Cedar Creek WWTP Improvements

Project No. 24022

ADDENDUM NO. 2 TO THE CONTRACT DOCUMENTS

CEDAR CREEK WWTP IMPROVEMENTS

SHEET NO. 00GI015

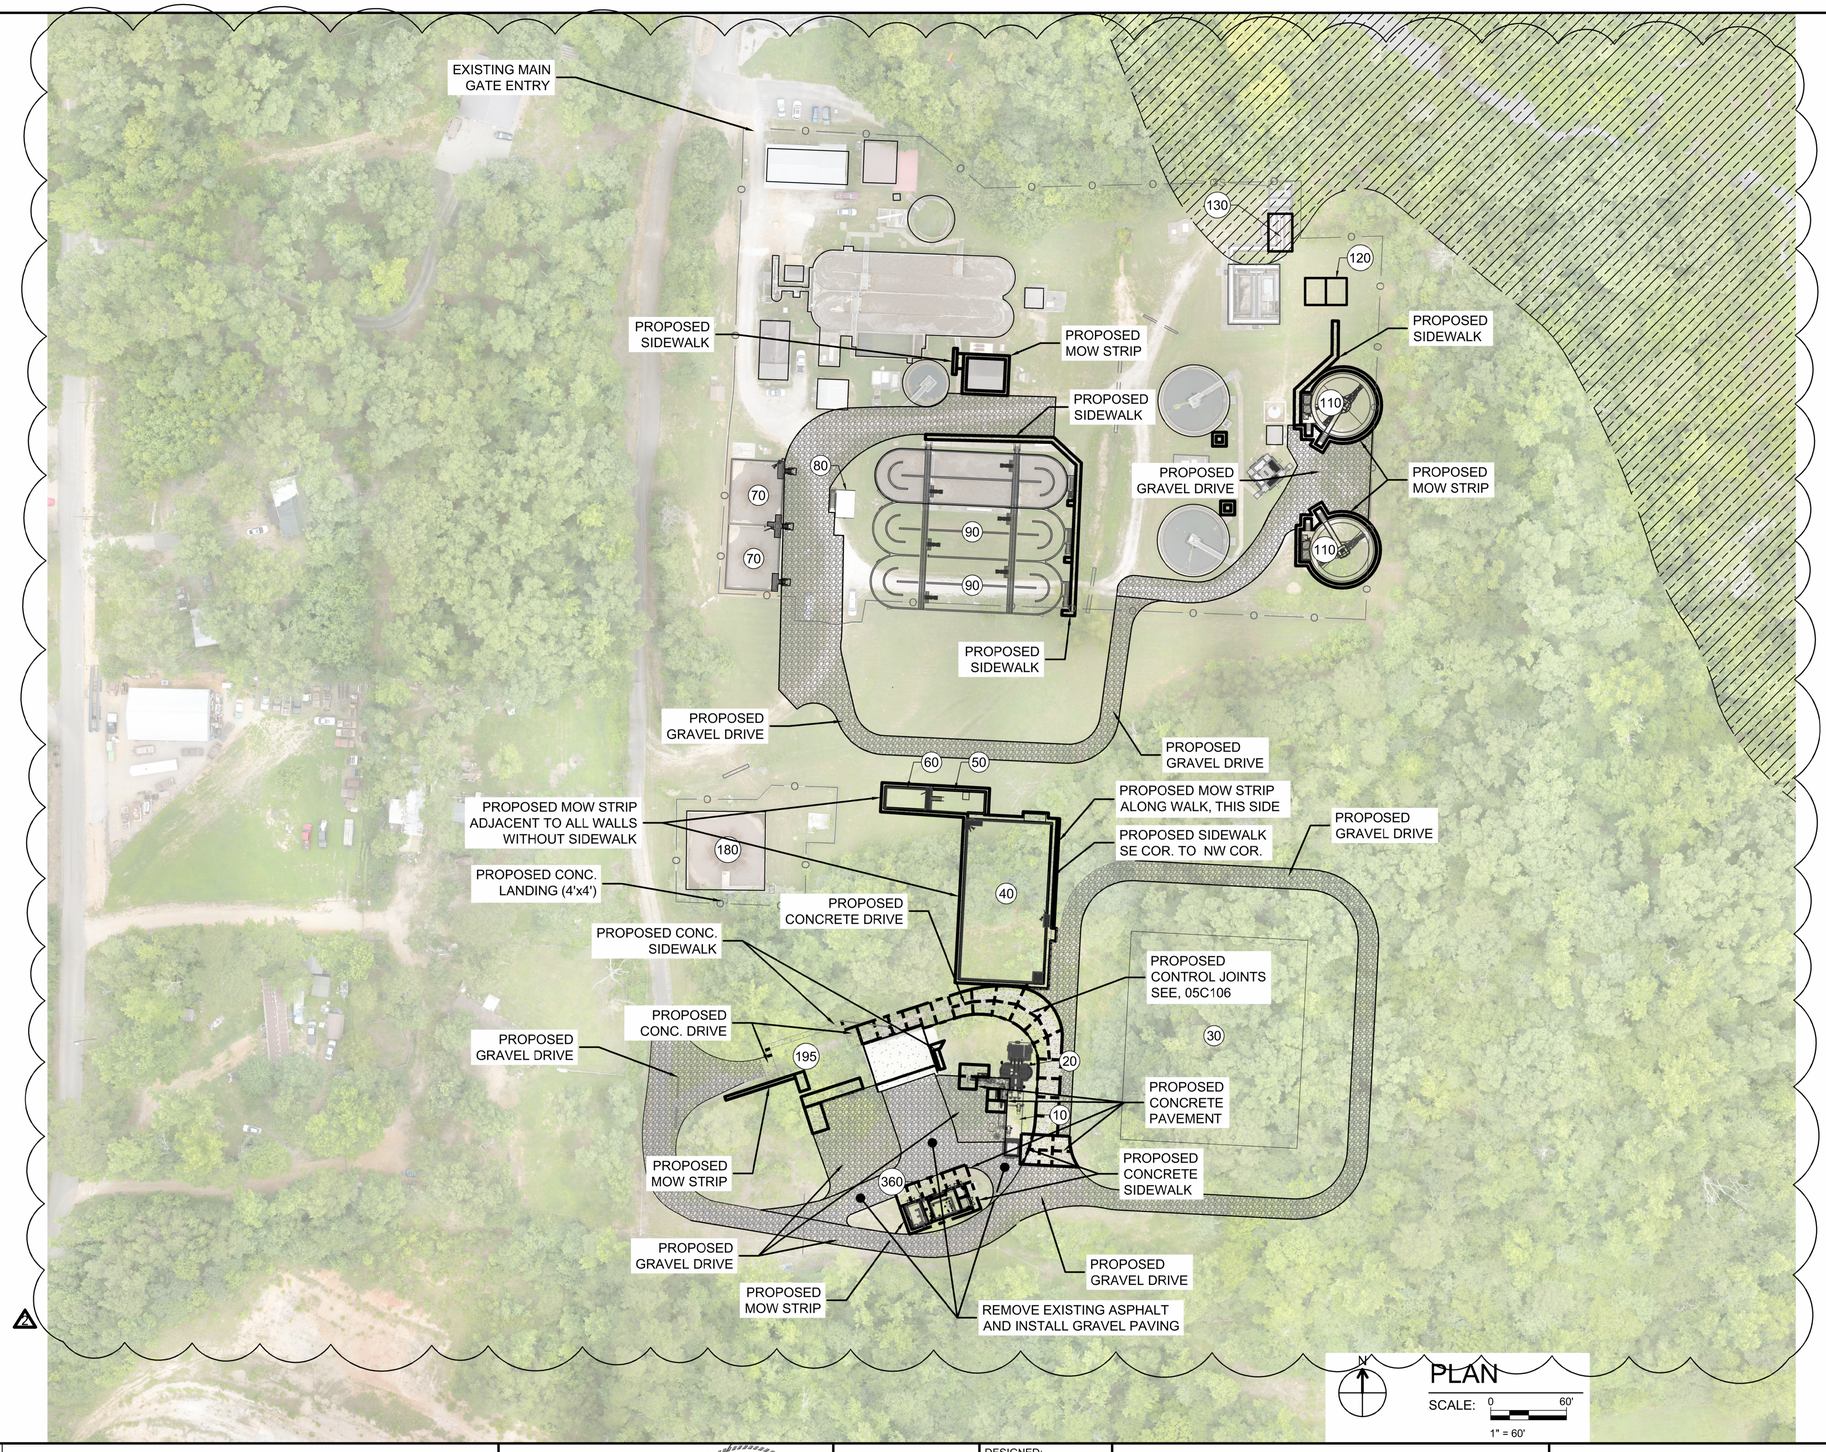
e. Delete Plan Sheets 00GI015 and replace with Plan Sheets 00GI015 Addendum No. 2.

REV. NO.	DATE	DRWN	CHKD	REMARKS
2	5/15/26	MAB	BNW	ADDED TWO VALVES TO THE SCHEDULE

SHEET NO. 05C109

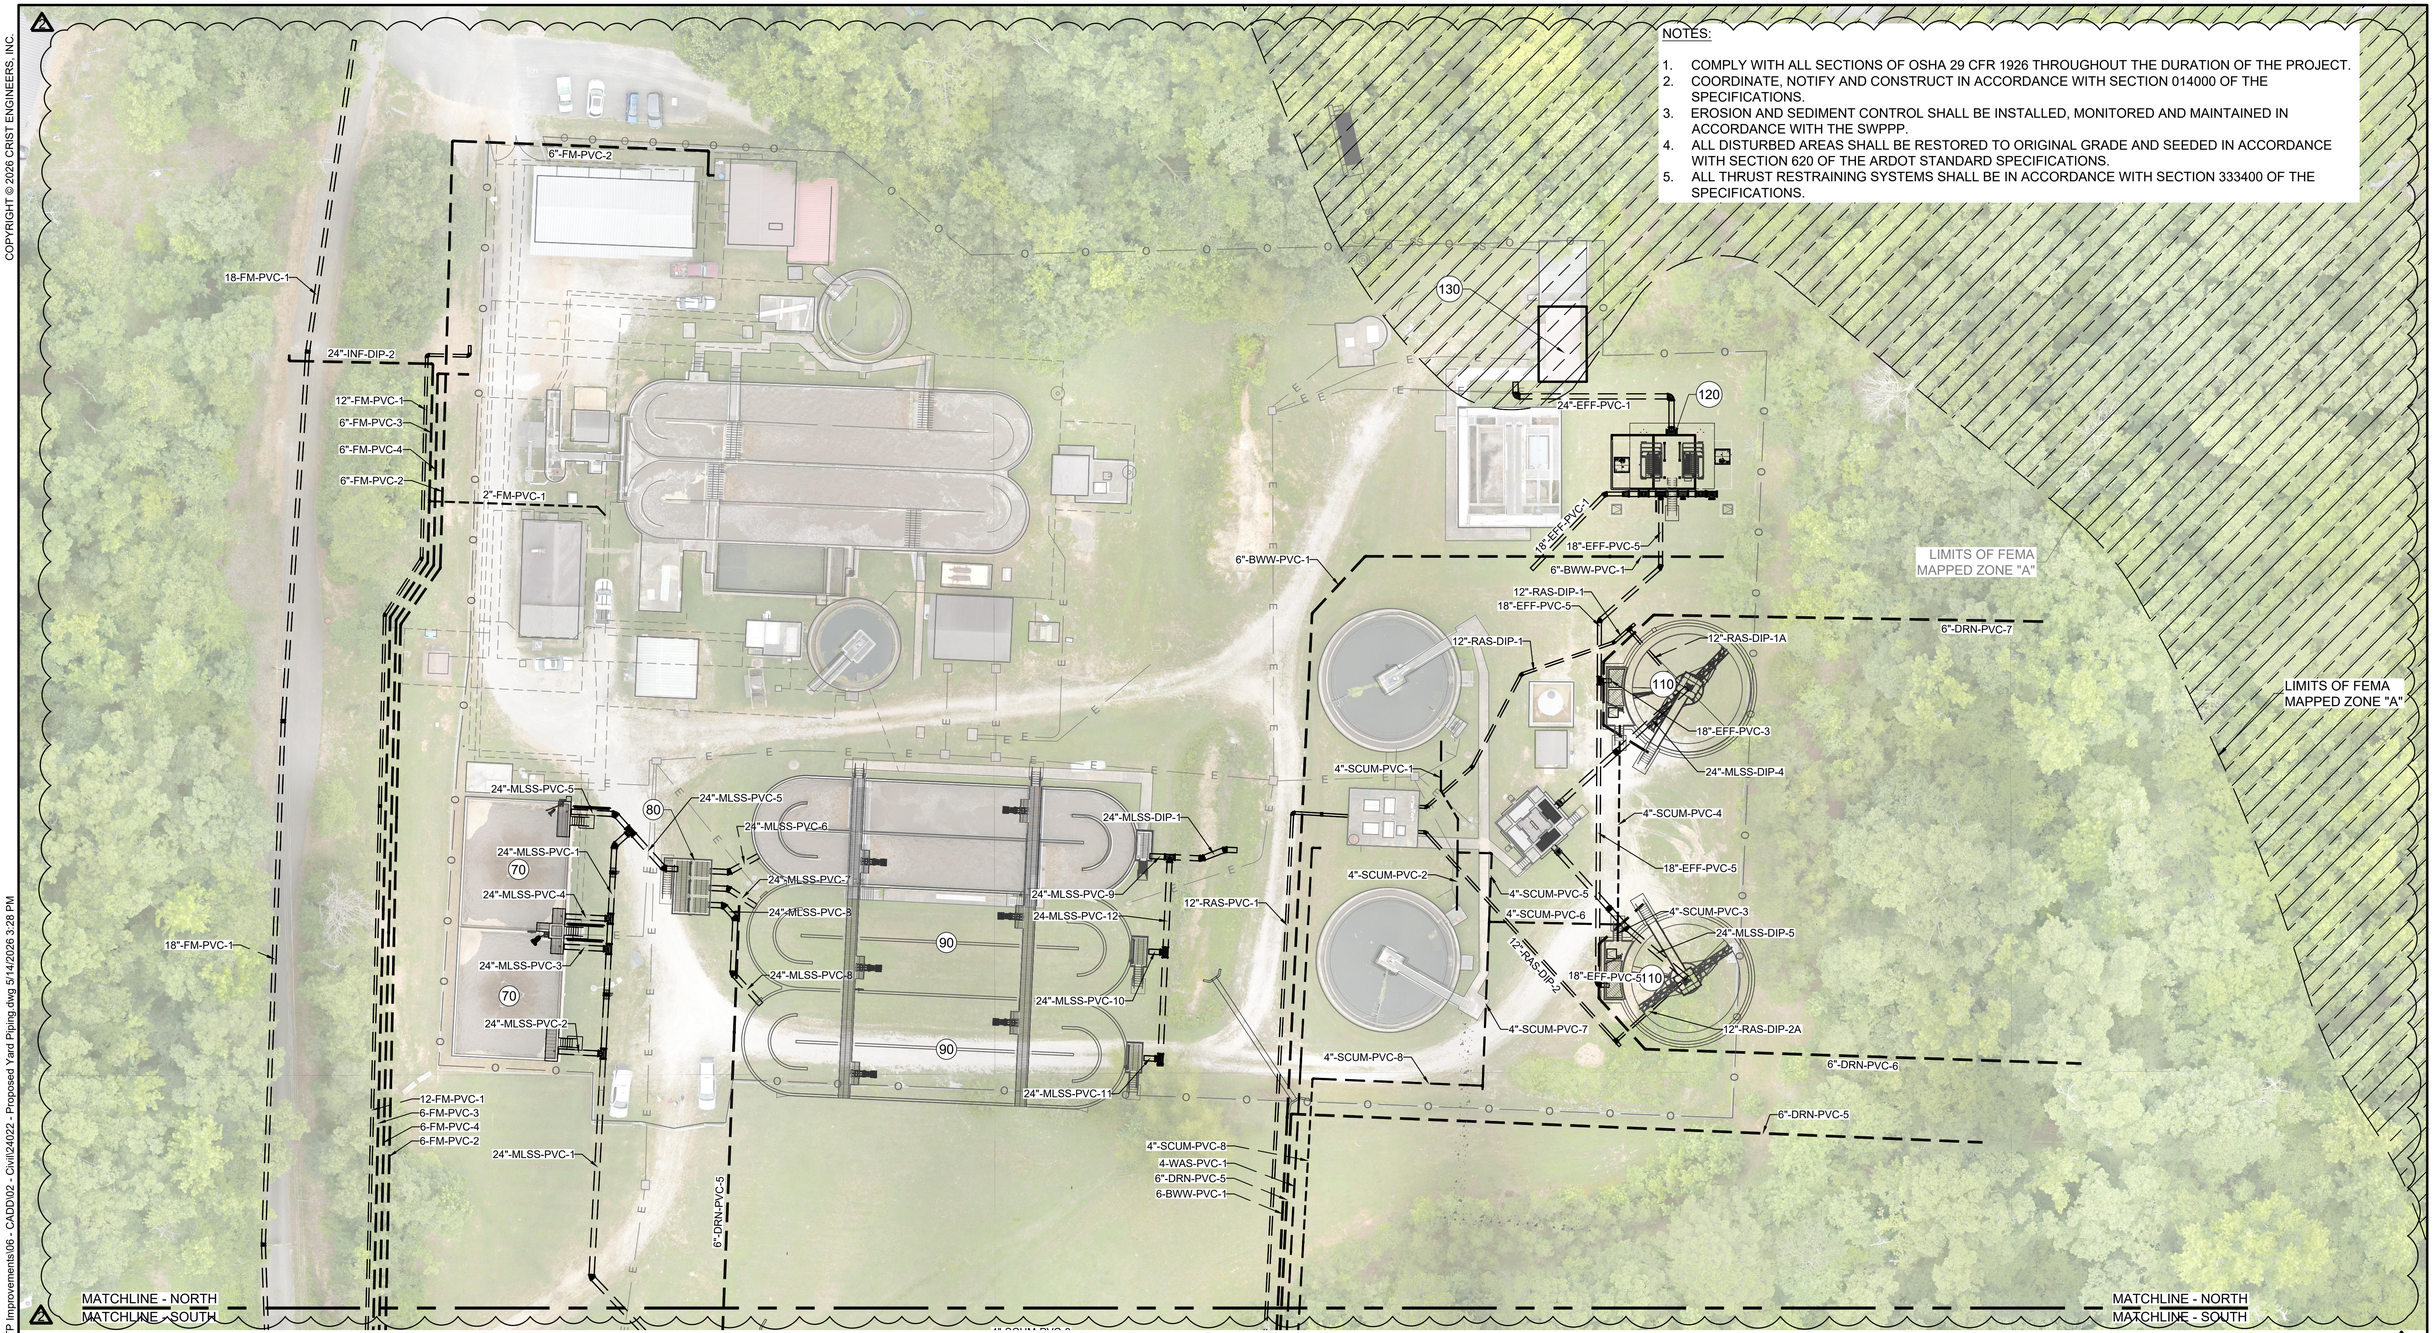
g. Delete Plan Sheets 05C109 and replace with Plan Sheets 05C109 Addendum No. 2.

All other areas identified within the plan set will be conformed to include removal of the existing asphalt and replace with gravel drive per revised plan sheet 05C109.

REV. NO.	DATE	DRWN	CHKD	REMARKS
2	5/13/26	MAB	BNW	CLEAN UP SHEET TO ONLY INCLUDE SURFACE REQUIREMENTS

SHEET NO. 05C111

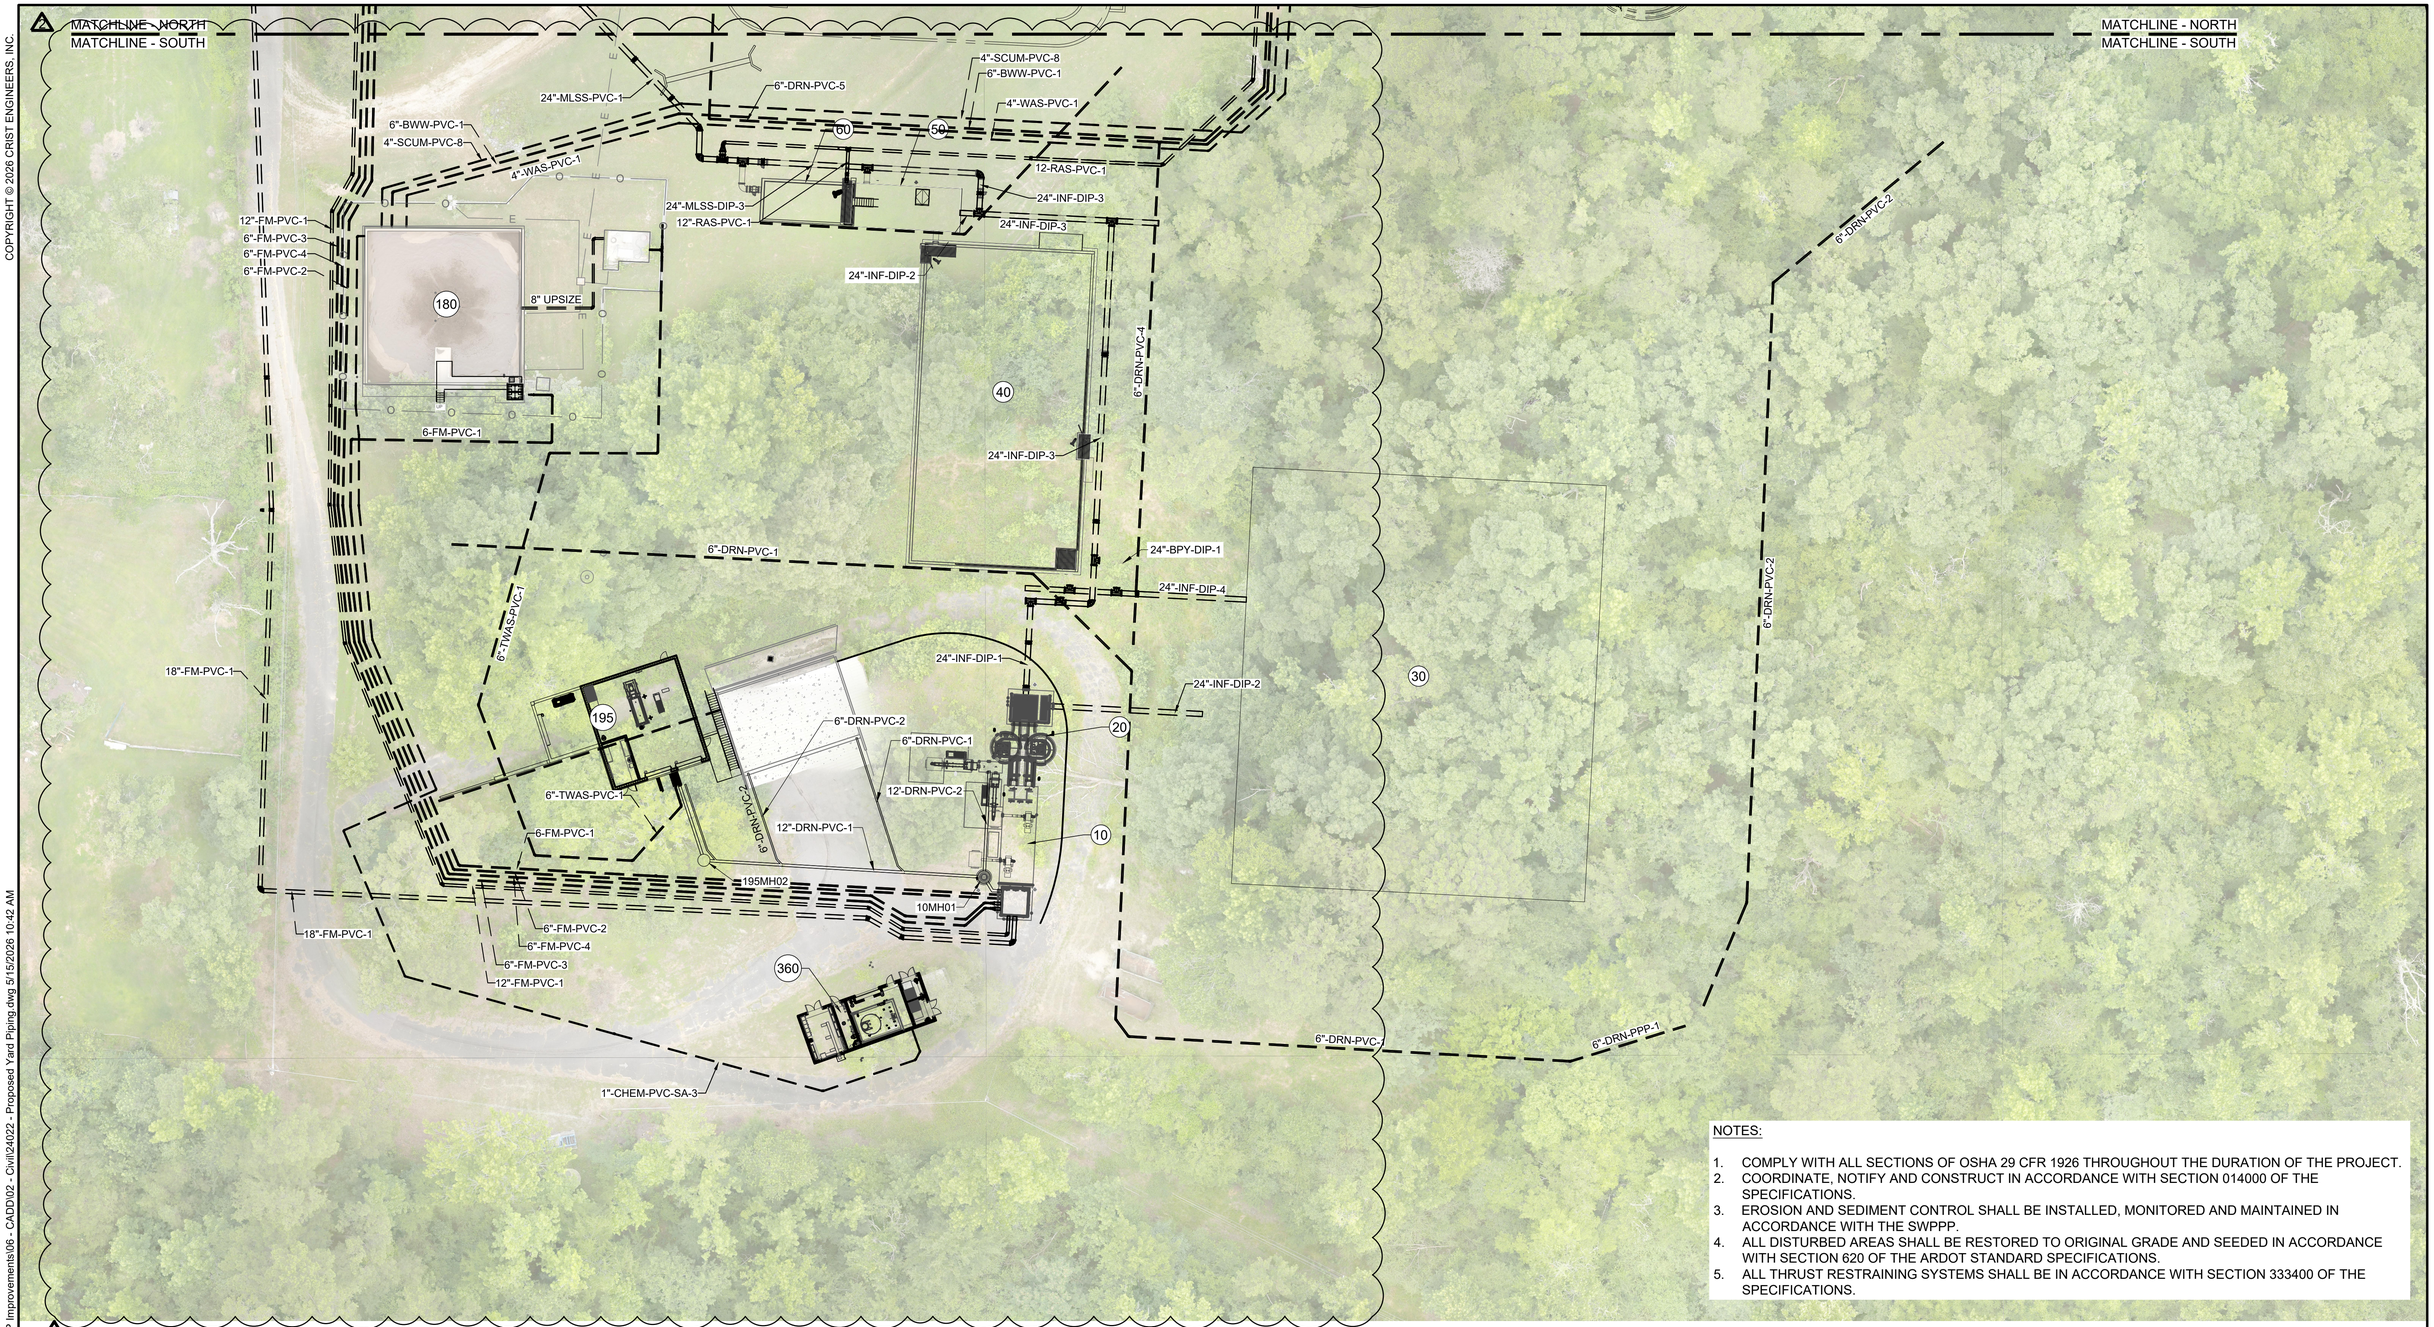
h. Delete Plan Sheets 05C111 and replace with Plan Sheets 05C111 Addendum No. 2.

REV. NO.	DATE	DRWN	CHKD	REMARKS
2	5/15/26	MAB	BNW	REMOVED FUTURE PIPING FOR CLARITY (VERIFIED PIPING LABELS)
1	5/7/26	MAB	BNW	CONFORMED PER ADDENDUM NO. 1
